ARABIAN ACRES METROPOLITAN DISTRICT
DISTRIBUTION SYSTEM IMPROVEMENT PROJECT
FINAL ENGINEERING DRAWINGS
MARCH 2020

PROJECT: DISTRIBUTION SYSTEM FINAL DESIGN
PROJECT NUMBER: 1289
CLIENT: ARABIAN ACRES METROPOLITAN DISTRICT
LOCATION: UNINCORPORATED TELLER COUNTY, COLORADO
DESIGNED BY: MIKE GROSELLE, P.E.
CHECKED BY: ADAM SOMMERS, P.E.
FILE PRINTED ON: 3/27/2020 2:28:32 PM
COPYRIGHT: AQUAWORKS DBO, INC.
DRAWING SIZE: 22" X 34"

LADY LN TO GERKA LN WATERLINE
STA 1+00 TO END

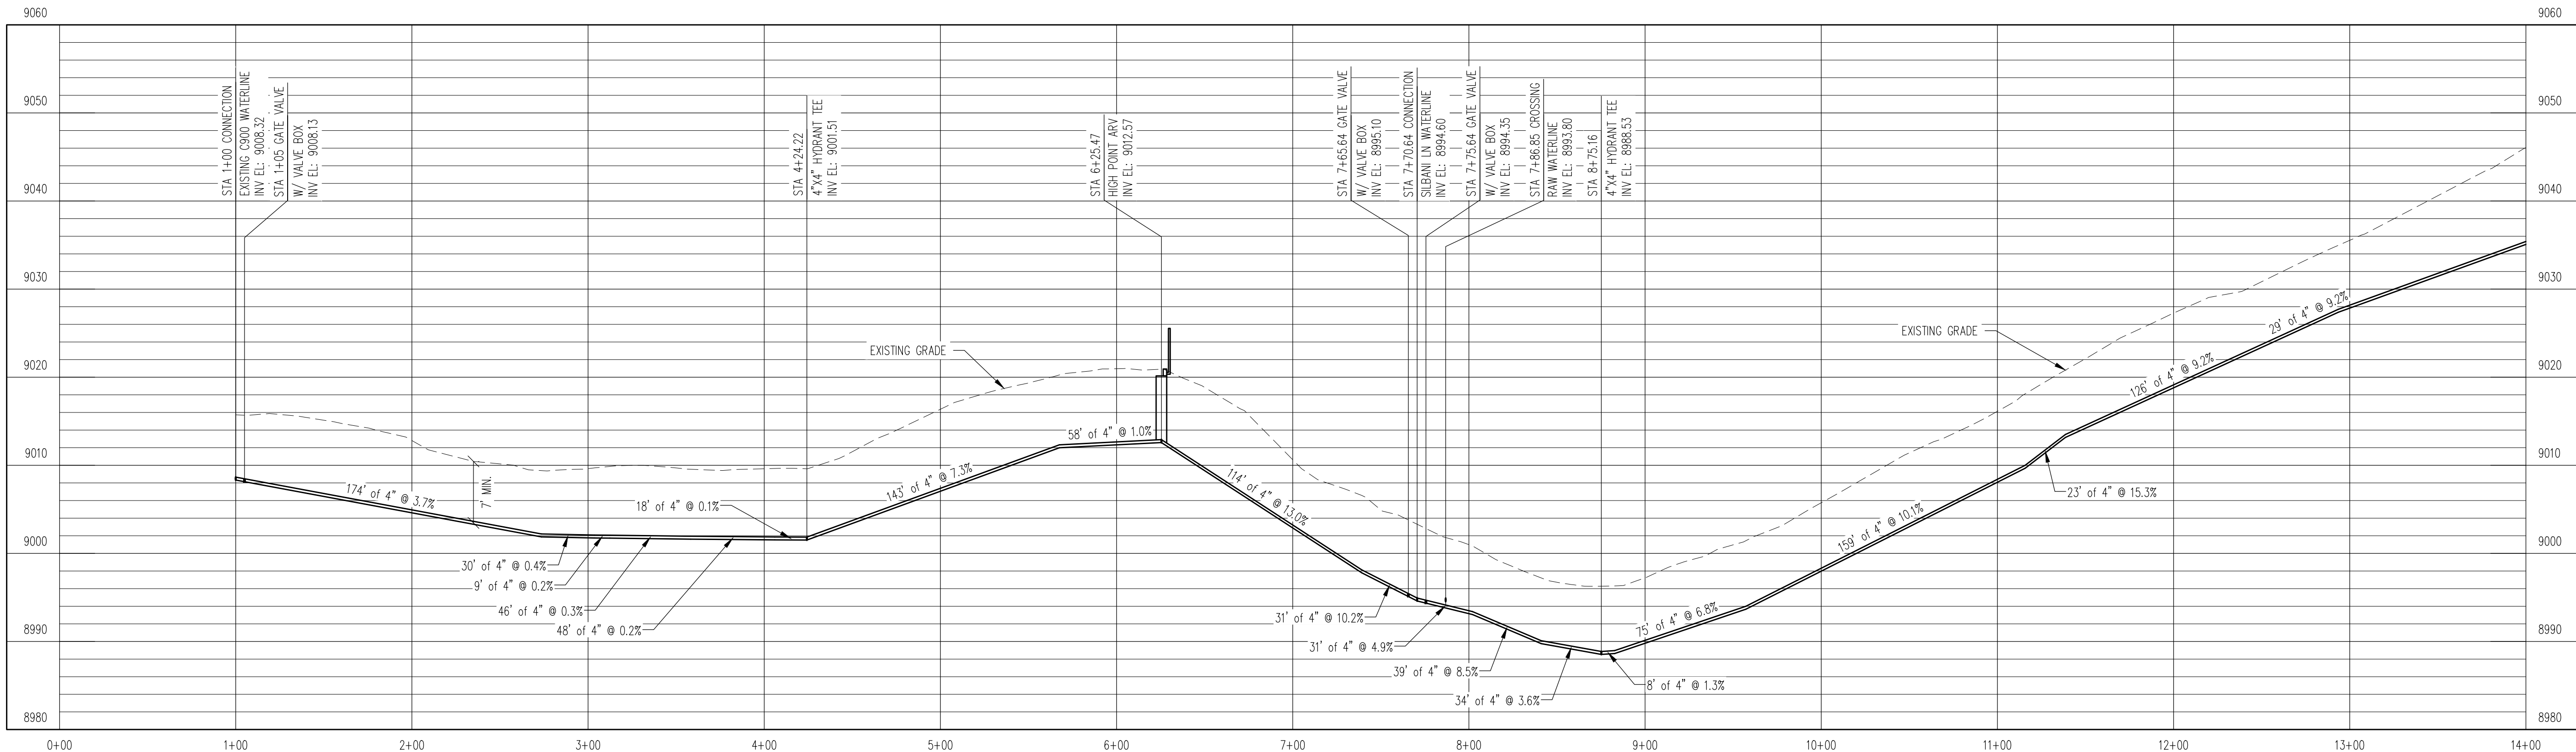
Installed pipe
to here 07/18

installed pipe
to here 07/20

Hit and caped
existing 4"
waterline in
here 7/21

BANNER TR II WATERLINE - II
STA 14+00 TO END

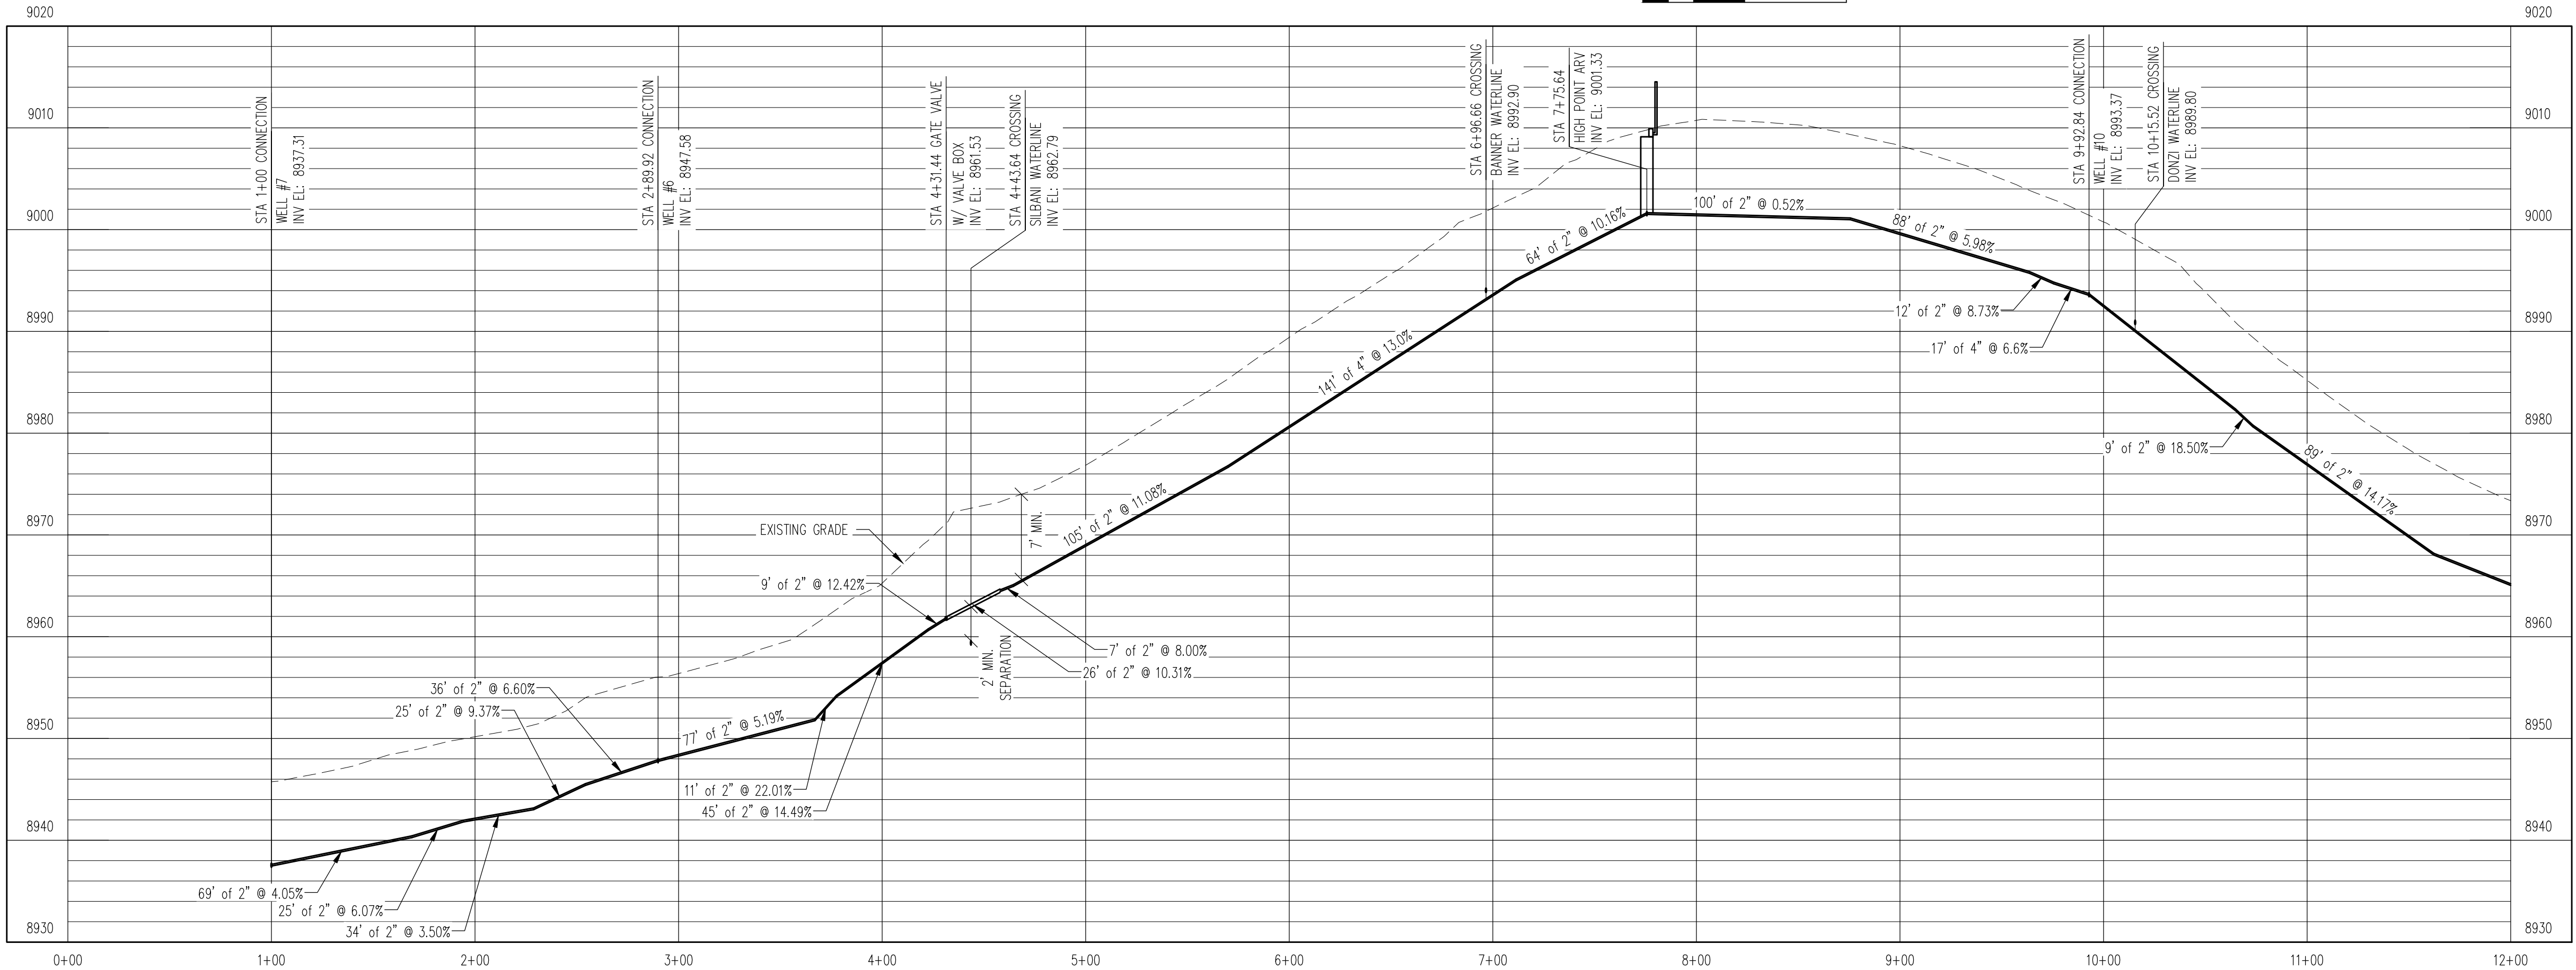
Pipe installed
to here 7/21

pipe installed
8/1
